Shop Drawing Submittal Review

Project Name: Webster University-**ISB**

PROJECT NAME: Webster University ISB
LOCATION: St. Louis Missouri
CLIENT PROJ. NO.: N/A
WES PROJ. NO.: 607
SPEC SECTION: 22 1319 Sanitary Waste Piping Specialties
SUBMITTAL ITEM: See Below -

RE: Sanitary Specialties Product Data

6000 Adjustable Round Floor Cleanout

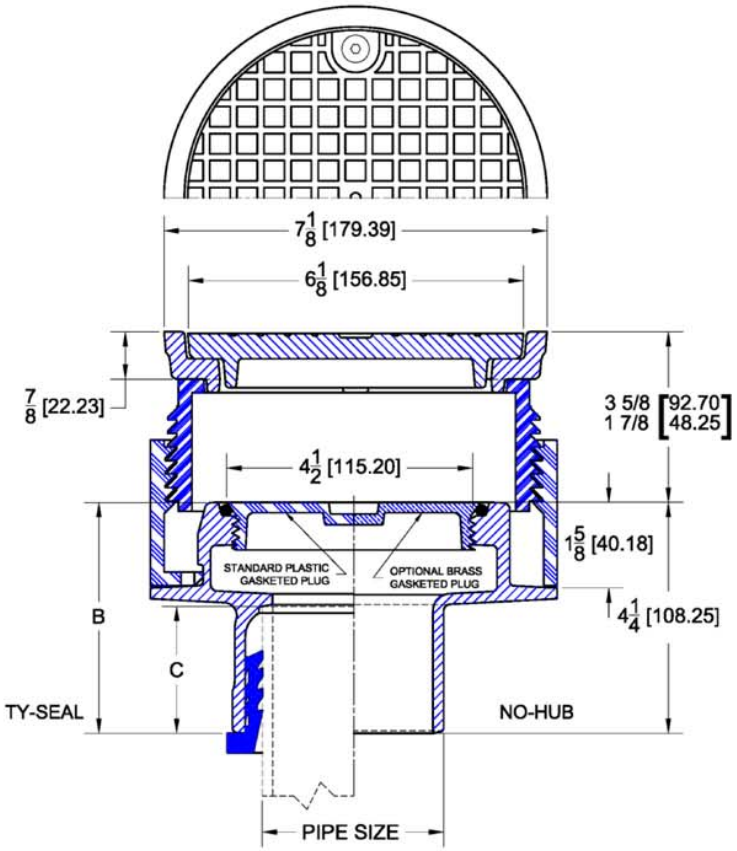
FCO-2		FCO-2 FLOOR CLEANOUT PER ADDENDUM #2-1
W600012NH75	WADE	ADJUSTABLE FLOOR & GRADE CLEANOUT, NICKEL BRONZE TOP - 2" NO HUB, BRONZE PLUG
W600013NH75	WADE	ADJUSTABLE FLOOR & GRADE CLEANOUT, NICKEL BRONZE TOP - 3" NO HUB, BRONZE PLUG
W600014NH75	WADE	ADJUSTABLE FLOOR & GRADE CLEANOUT, NICKEL BRONZE TOP - 4" NO HUB, BRONZE PLUG
